DEPARTMENT OF TRANSPORTATION

Contract #: 04-0120F4Cty: SF/ALA Rte: 80 PM: 13.2/13.9File #: 69.28**WELDING INSPECTION REPORT****Resident Engineer:** Pursell, Gary**Address:** 333 Burma Road**City:** Oakland, CA 94607**Report No:** WIR-006832**Date Inspected:** 21-May-2009**Project Name:** SAS Superstructure**OSM Arrival Time:** 700**Prime Contractor:** American Bridge/Fluor Enterprises, a JV**OSM Departure Time:** 1700**Contractor:** Zhenhua Port Machinery Company, Ltd (ZPMC), Changxing Island **Location:** Shanghai, China**CWI Name:** Chen Xi**CWI Present:** Yes No**Inspected CWI report:** Yes No N/A**Rod Oven in Use:** Yes No N/A**Electrode to specification:** Yes No N/A**Weld Procedures Followed:** Yes No N/A**Qualified Welders:** Yes No N/A**Verified Joint Fit-up:** Yes No N/A**Approved Drawings:** Yes No N/A**Approved WPS:** Yes No N/A**Delayed / Cancelled:** Yes No N/A**Bridge No:** 34-0006**Component:** OBG crossbeams**Summary of Items Observed:**

OBG cross beam CB7

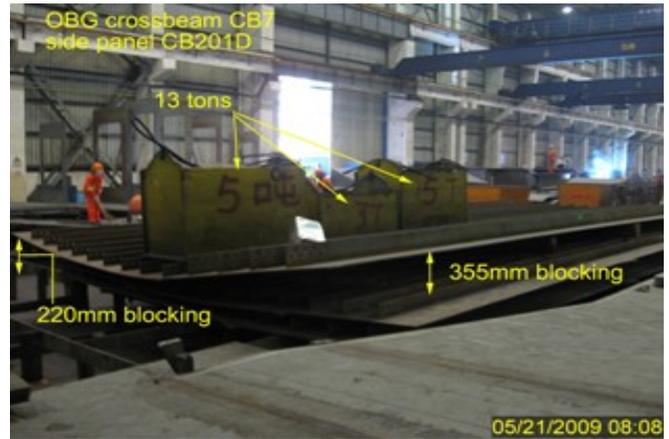
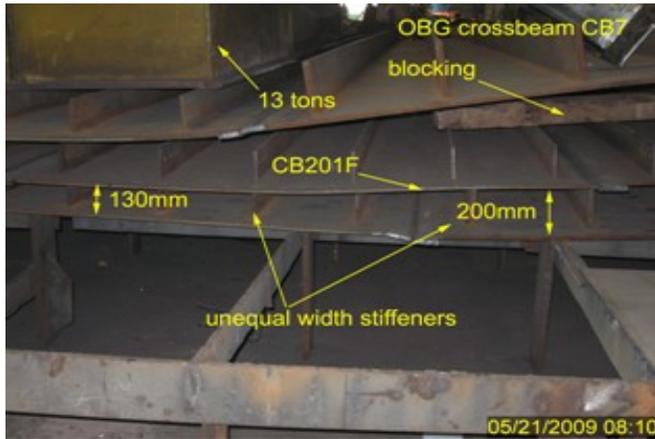
This Quality Assurance Inspector (QA) observed that the contractor has performed flame straightening on side panel identified as CB201D without an approved procedure. The procedure presented to this QA indicated that the distortion was 5mm on 18mm plate. This is non compliant to the Contract Special Provisions 8-3.01 which specifies "for material more than 16mm, the contractor shall not heat straighten members more than 3 in 1000 without prior approval of the Engineer. Furthermore, the contractors personnel did not follow the available procedure on the shop floor identified as Heat Straightening Report number HSR1(B)-6427. The procedure did not indicate the use of blocks under each edge of the panel as shown in the photos below.
